## ORIGINATION FORM

Proposed Revisions to a Standard Plans Index  
(Please provide all information — Incomplete forms will be returned)

Index Number: 711-003  
Sheet Number (s): 5 and 6  
Index Title: Interchange Markings

SHEET  
6 of 8

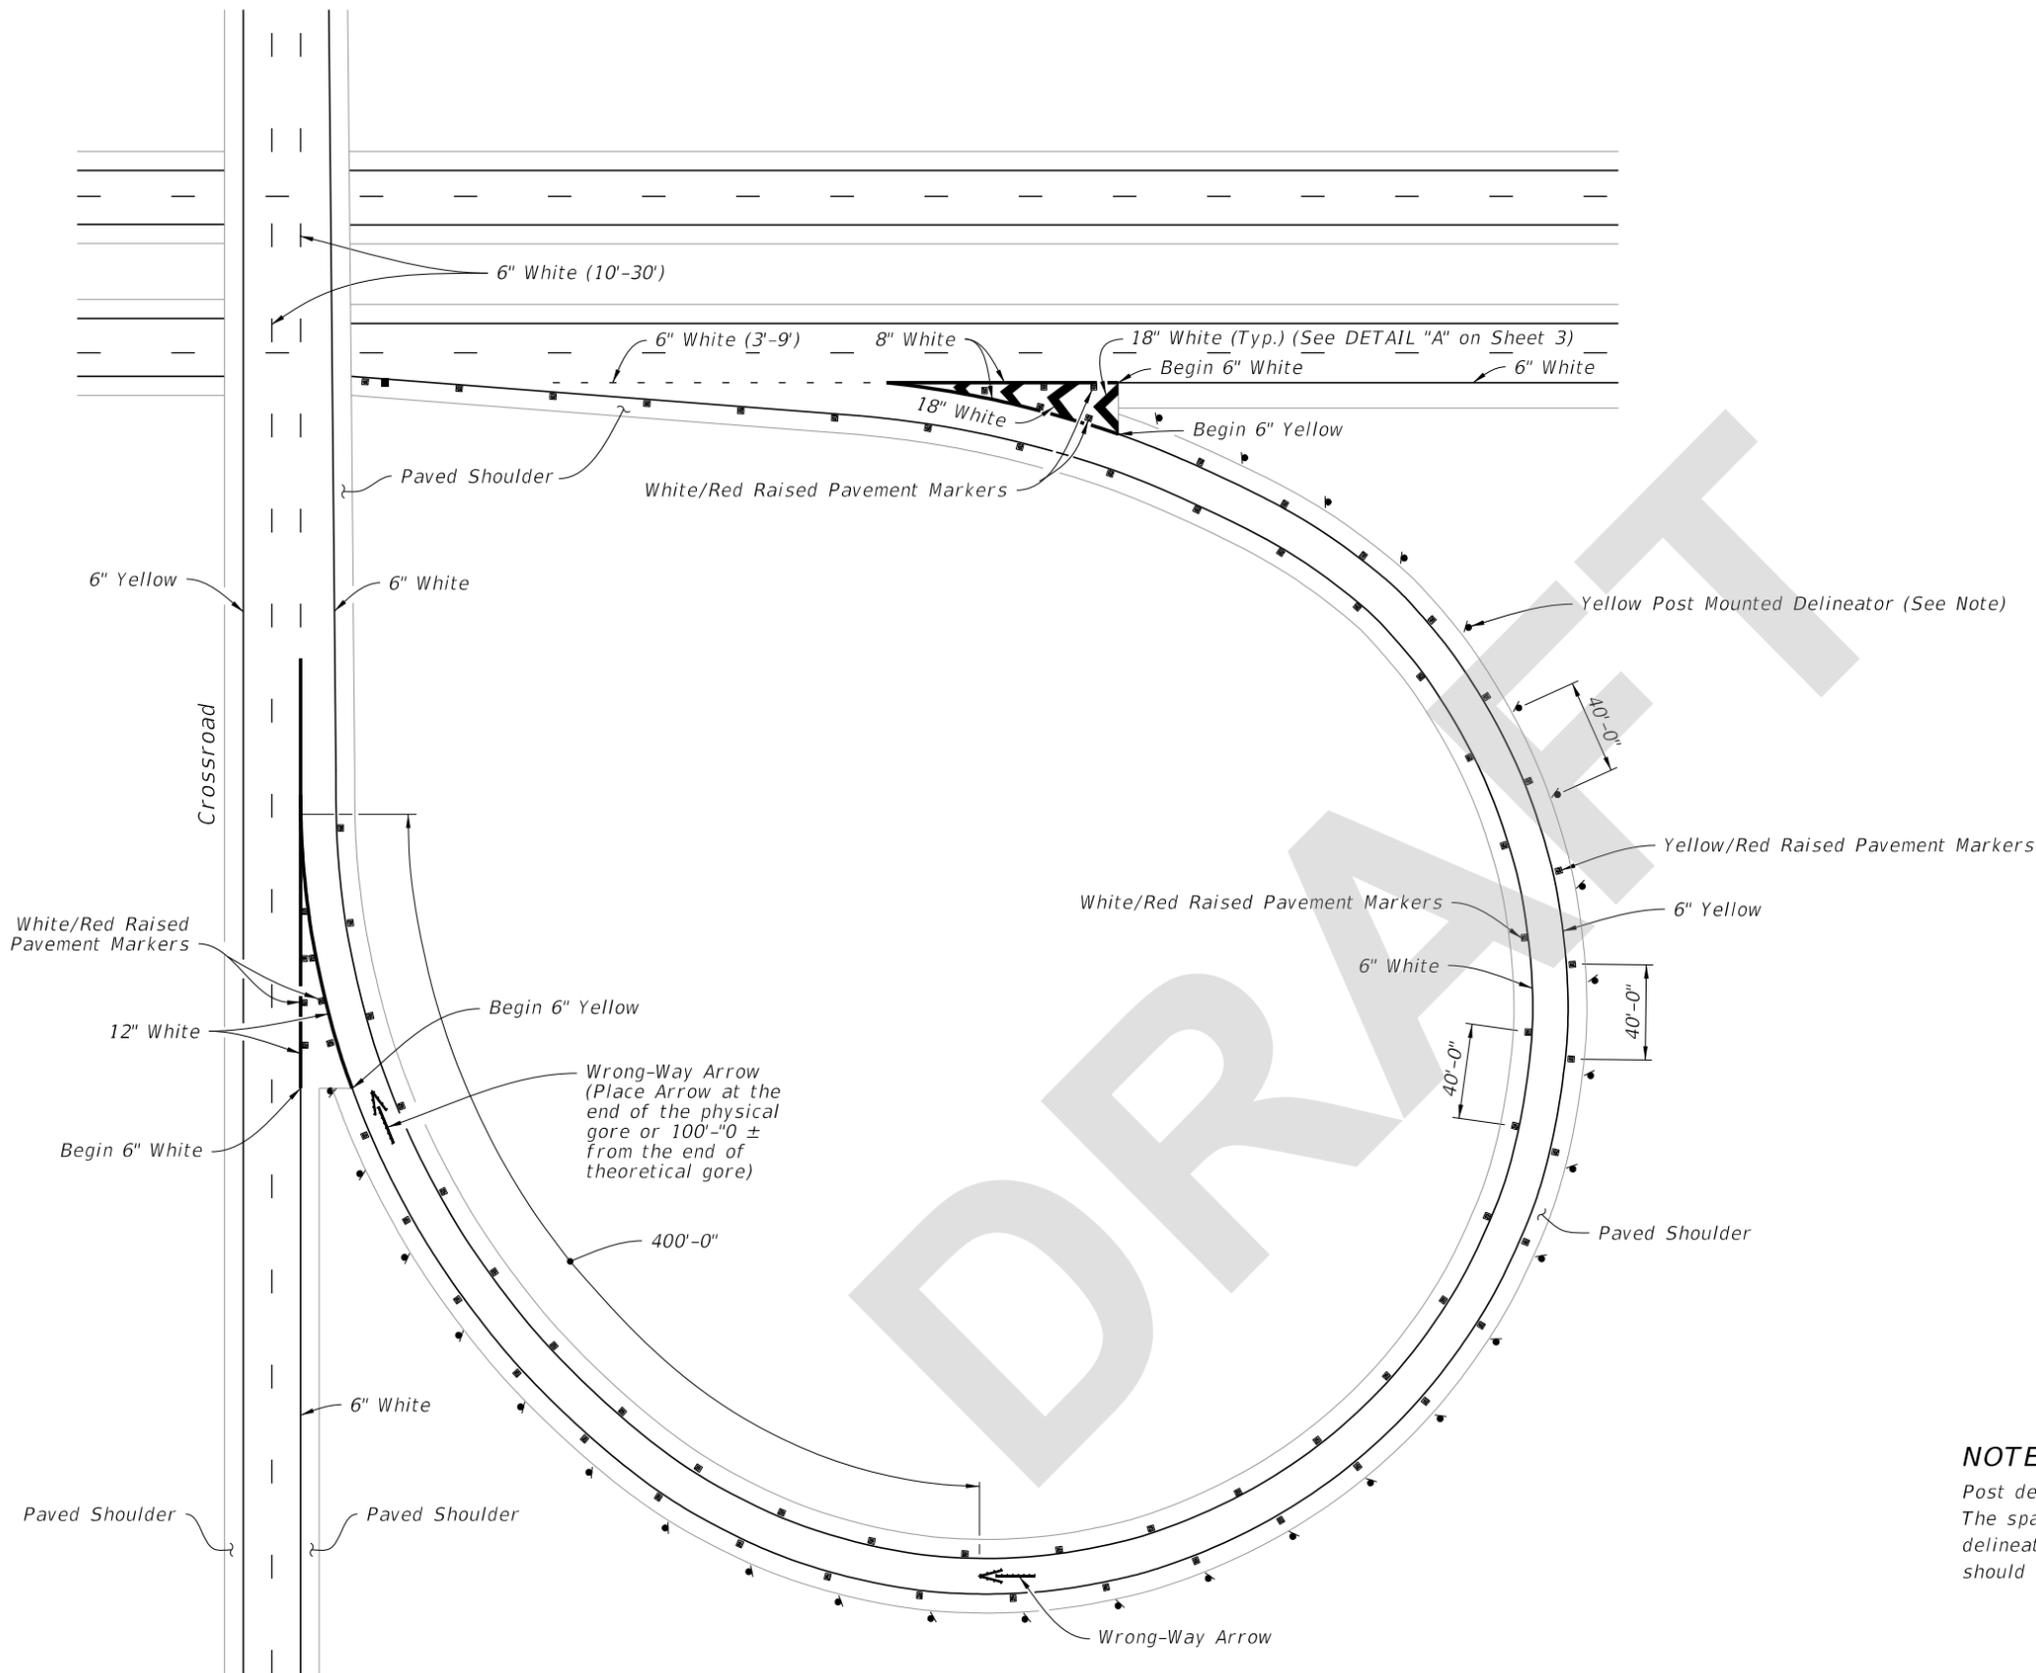
Sheet 6: Moved Note 1 to the Wrong-Way Arrow callout at the Gore; Deleted the note reference and the Detail"C" reference for the Wrong-Way Arrow callout on the off ramp.

~~Wrong-Way Arrow (See Note 1)  
(See DETAIL "C", Sheet 5)~~

**CHANGED TO:**  
Wrong-Way Arrow  
(Place Arrow at the end of the physical gore or 100'-0" +/- from the end of the theoretical gore)

~~Wrong Way Arrow  
(See Note 1)~~

- ~~1. Place the Wrong Way Arrow at the end of the physical gore or 100'-0" +/- from the end of theoretical gore.~~
- ~~2. Post delineators spaced at 40' on curves of the entrance and exit of ramps. The spacing on the tangent portion of the ramp section is 300'-0". All delineators are to be setback 4' from shoulder break. Post delineators should not be discontinued in sections with guardrail.~~

Post delineators spaced at 40' on curves of the entrance and exit of ramps. The spacing on the tangent portion of the ramp section is 300'-0". All delineators are to be setback 4' from shoulder break. Post delineators should not be discontinued in sections with guardrail.
